**WATER TREATMENT PLANT IMPROVEMENTS
TOWN OF SMITHFIELD
JOHNSTON COUNTY, NORTH CAROLINA**

SUBJECT: ADDENDUM NO. 1

NOVEMBER 6, 2020

To the Plans and Specifications for:
Water Treatment Plant Improvements
Smithfield, N.C.

A1-1

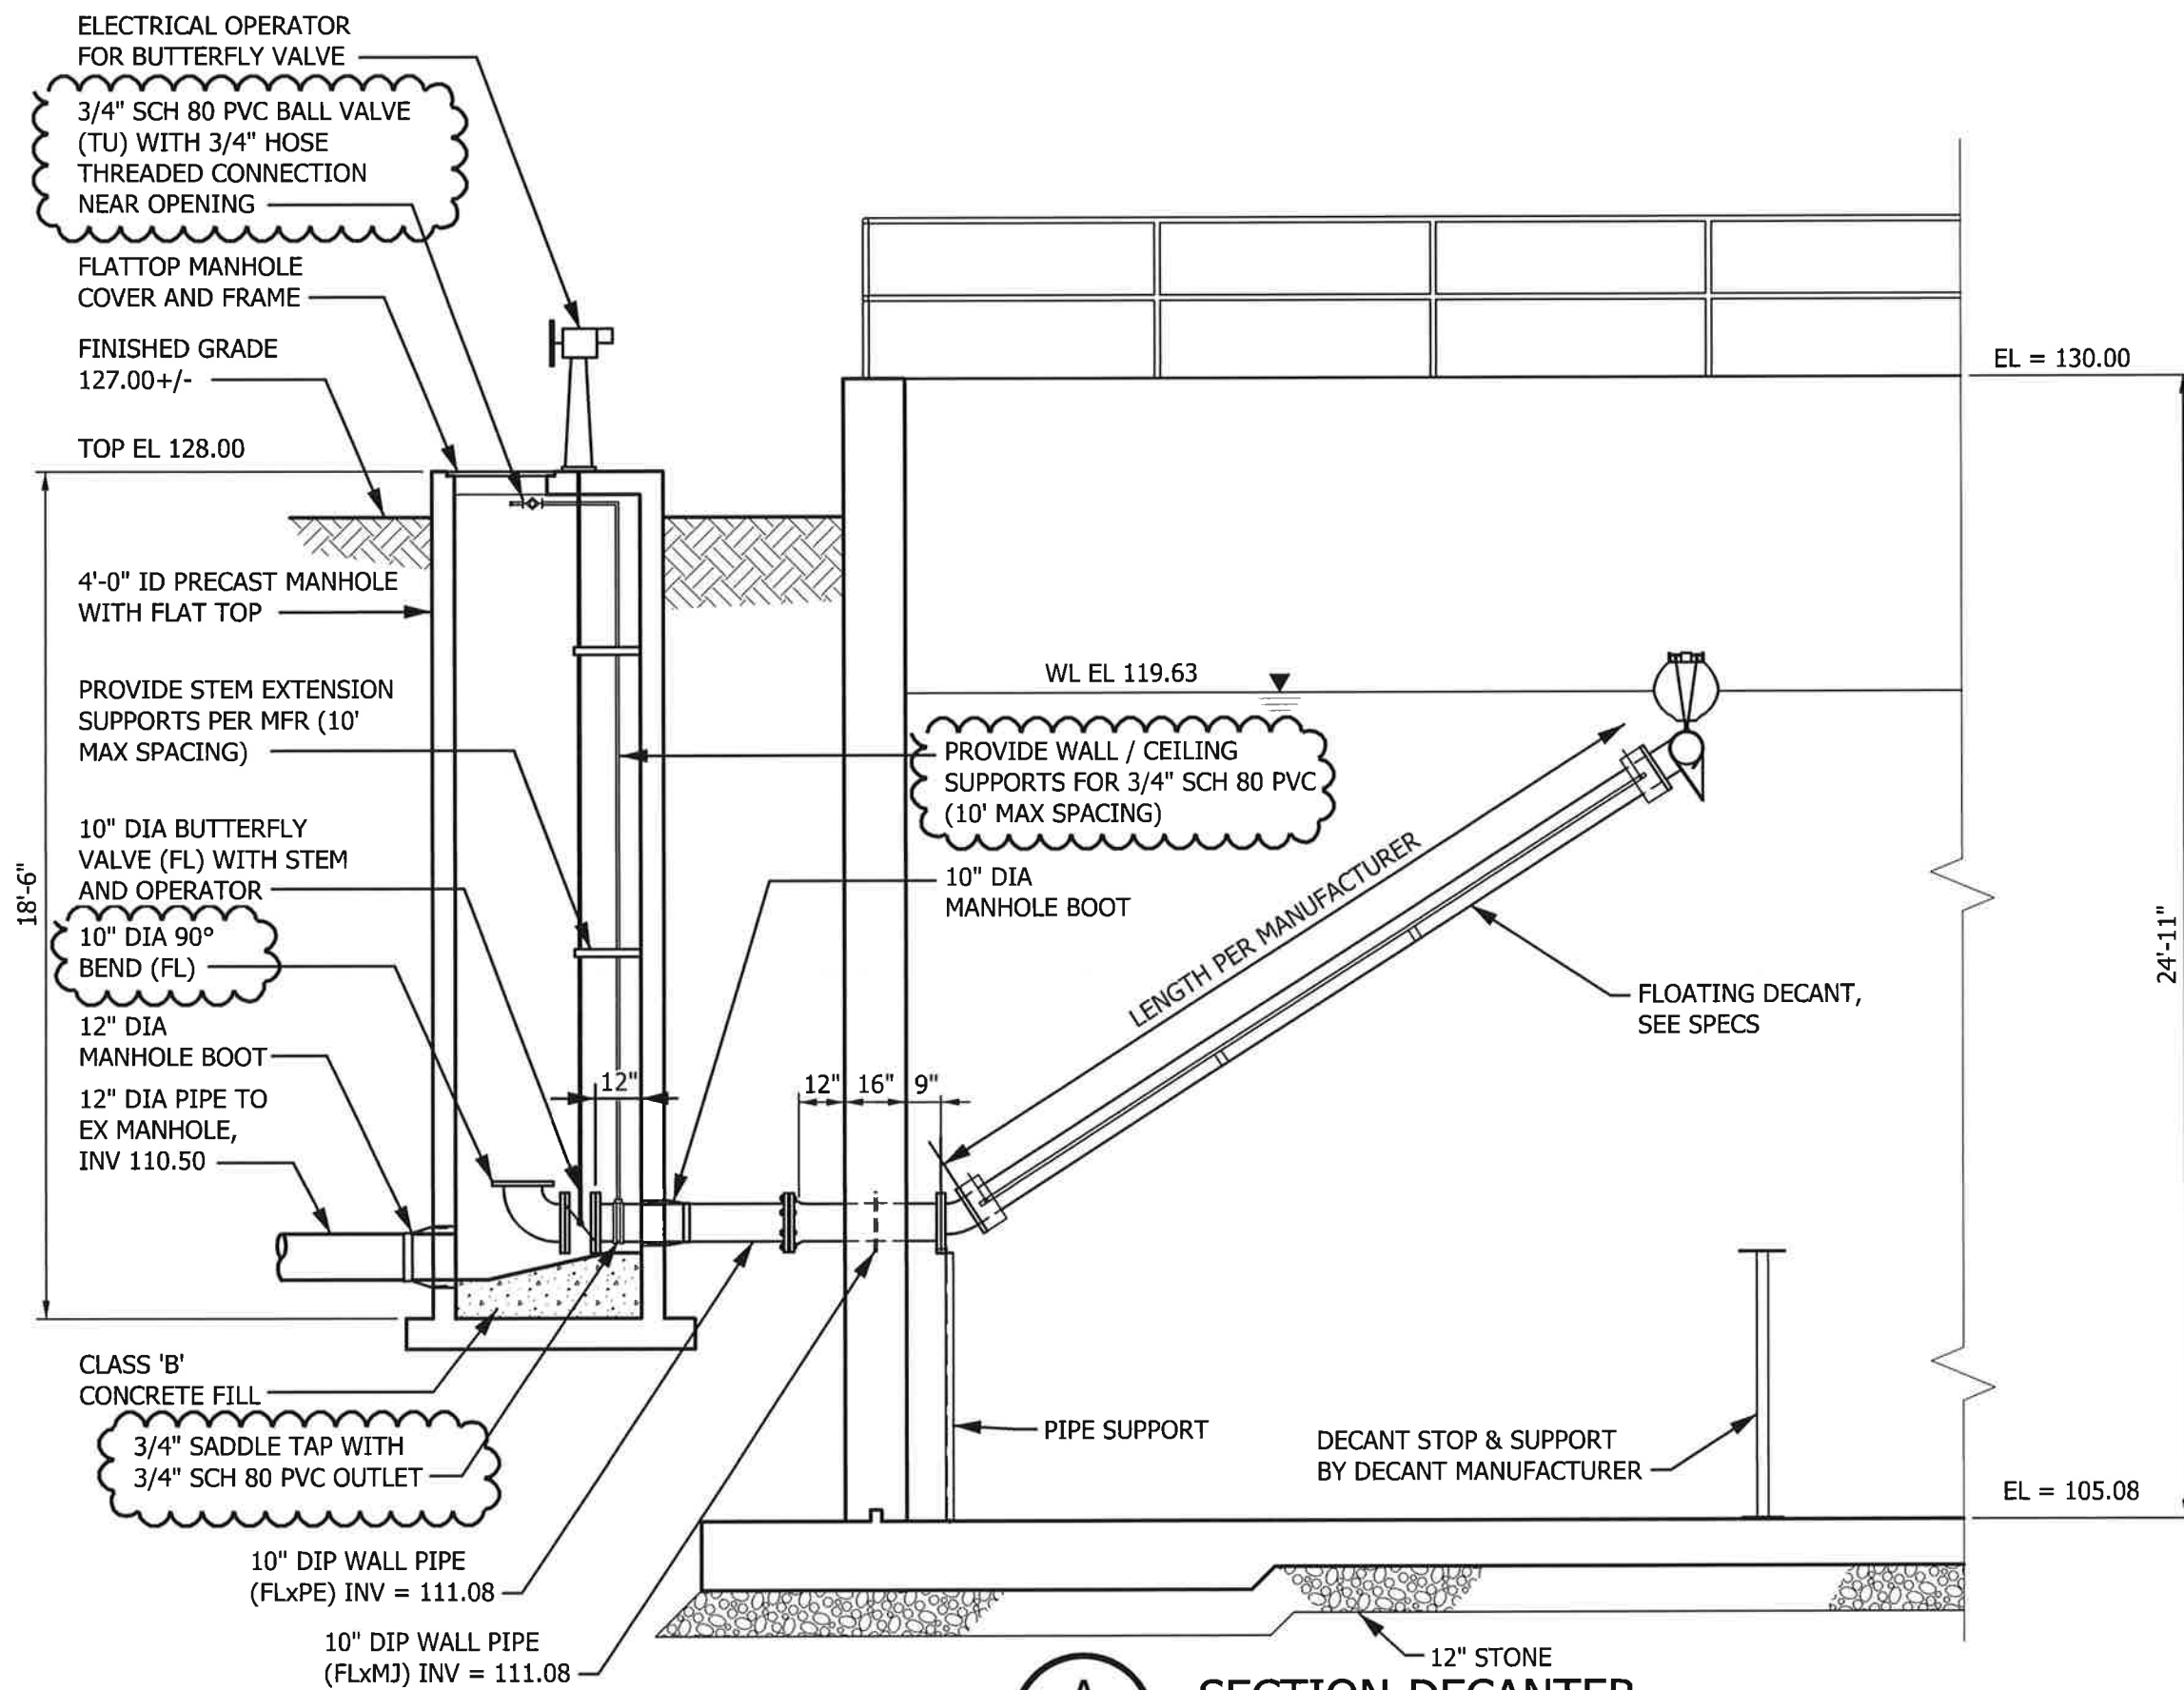
- 1. Sheet No. C204, WTP Piping Plan
 - a. See attached Drawing A1-1 showing new 12" drain line from Sedimentation Basin No. 4 extending to new MH #7B. Note adjustments to new MH #7B for 12" Drain Line Invert In.
